# Office Action Summary

10/518,205

## **DETAILED ACTION**

**Claims 1-3, 7-10, 12, 13, 16, 18-20, and 22-25 are rejected under 35 U.S.C. 102(b) as being anticipated by Andris (US 5,014,881).**

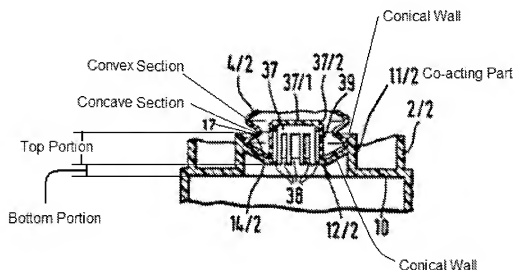
and column 15, lines 45-48); a co-acting part 11/2 or 11/4, including: a top portion; and a conical outer wall (see marked-up figure 6 and figure 12); wherein the turned-back edge 17 of the bellows part rests on the top portion of the co-acting part and the bellows part co-operates with the co-acting part 11/2 or 11/4 (see marked-up figure 6 and figure 12).

Regarding claim 9, Andris discloses the flexible wall further includes a concave cross-section (see marked-up figure 6).

Regarding claim 10, Andris discloses the flexible wall further includes a convex cross-section (see marked-up figure 6).

Regarding claim 24, Andris discloses the outer wall of the co-acting part 11/2 includes a first and second conical part (see marked-up figure 6).

Regarding claim 25, Andris discloses the first conical part includes an angle of inclination which is different than an angle of inclination of the second conical part (see marked-up figure 6).
